SUBJECT: ISSUANCE OF AMENDMENT - EDWIN I. HATCH NUCLEAR PLANT, UNIT 1
(TAC NO. M98387)

EDWIN I. HATCH NUCLEAR PLANT, UNIT 1

Amendment No. 207
License No. DPR-57

SAFETY EVALUATION BY THE OFFICE OF NUCLEAR REACTOR REGULATION
RELATED TO AMENDMENT NO. 207 TO FACILITY OPERATING LICENSE DPR-57

Figure 3.4.9-1 (Page 1 of 1)
Pressure/Temperature Limits for
Inservice Hydrostatic and Inservice Leakage Tests

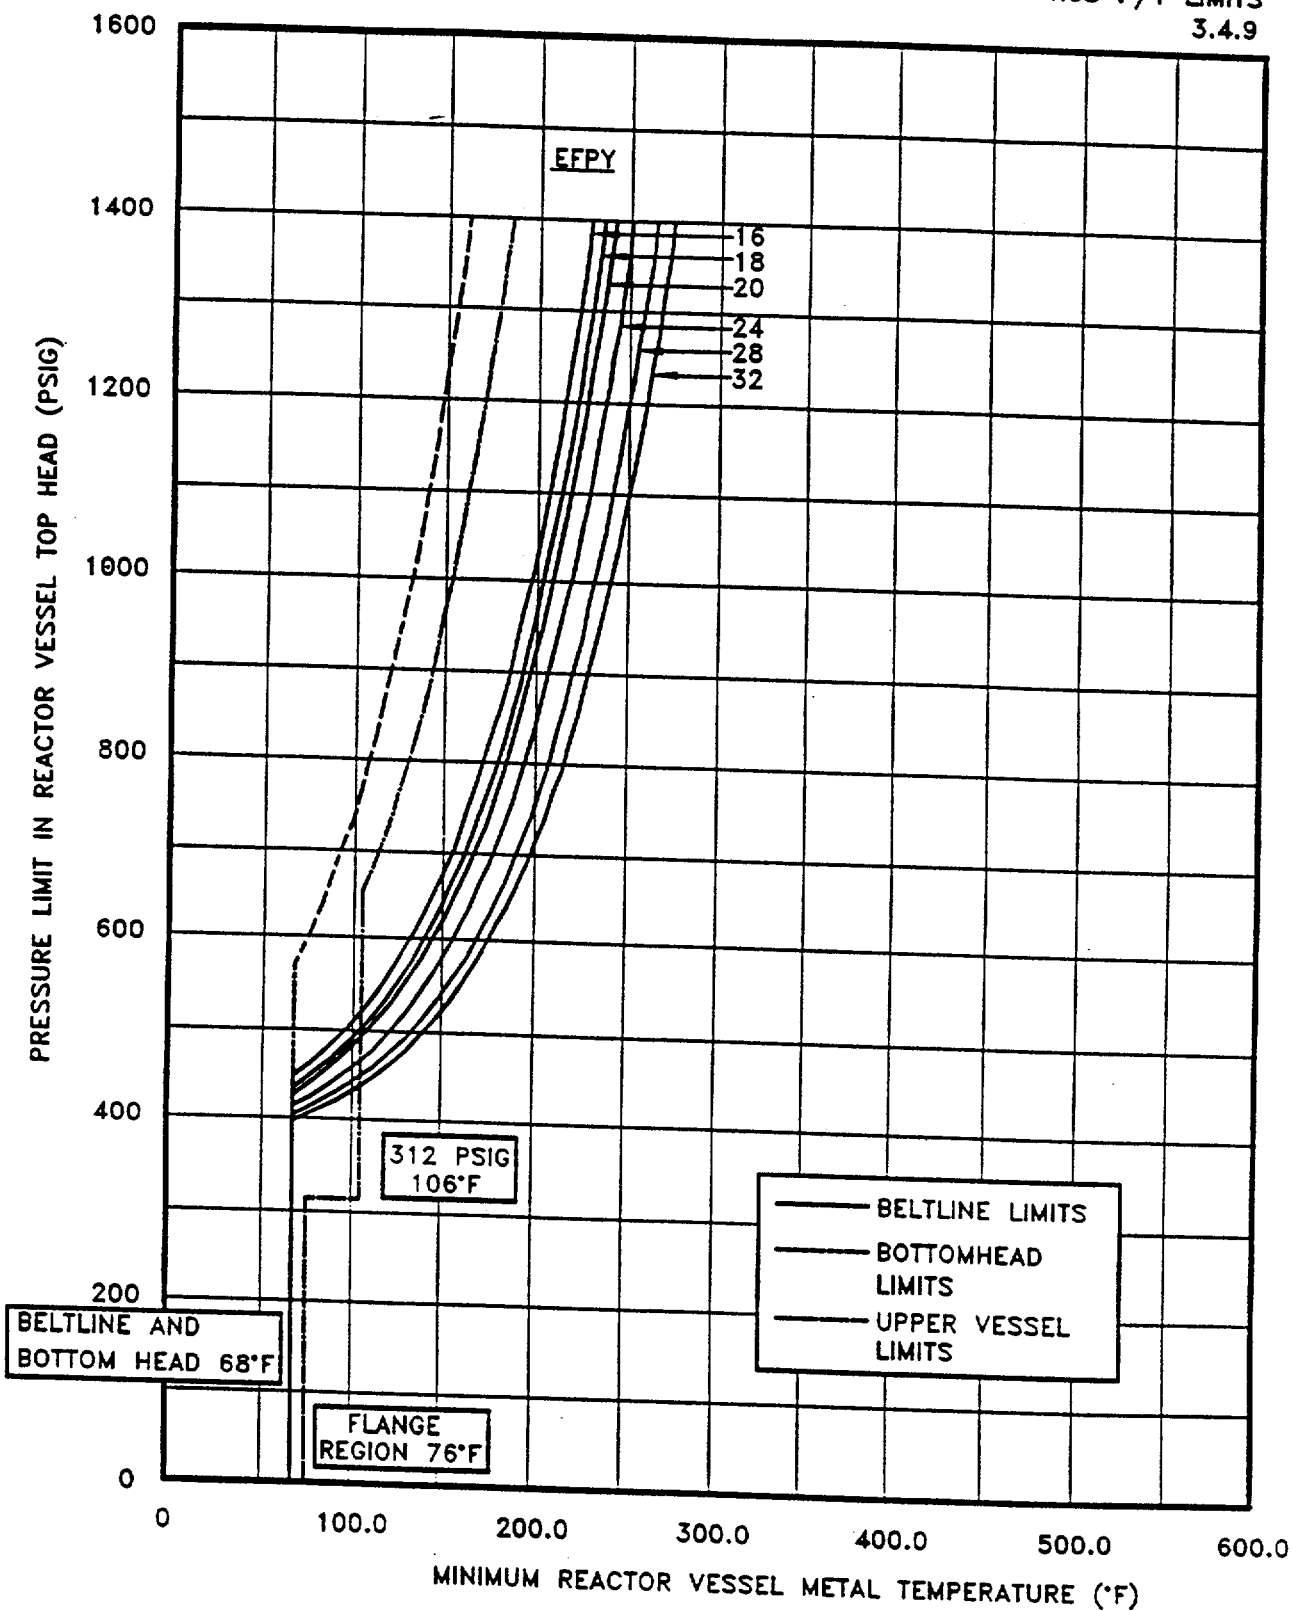
The amendment revises the Hatch Unit 1 reactor vessel pressure and temperature limits to reflect data collected from the material sample recovered during the March 1996 Unit 1 outage.

Replace the following pages of the Appendix "A" Technical Specifications with the enclosed pages. The revised pages are identified by Amendment number and contain vertical lines indicating the areas of change.

The staff has performed an independent analysis to verify the licensee's proposed P-T limits. The staff concludes that the proposed P-T limits are valid to 32 EFY since the limits conform to the requirements of Appendix G of 10 CFR Part 50 and GL 88-11. Hence, the proposed P-T limits may be incorporated in the Hatch Unit 1 Technical Specifications.
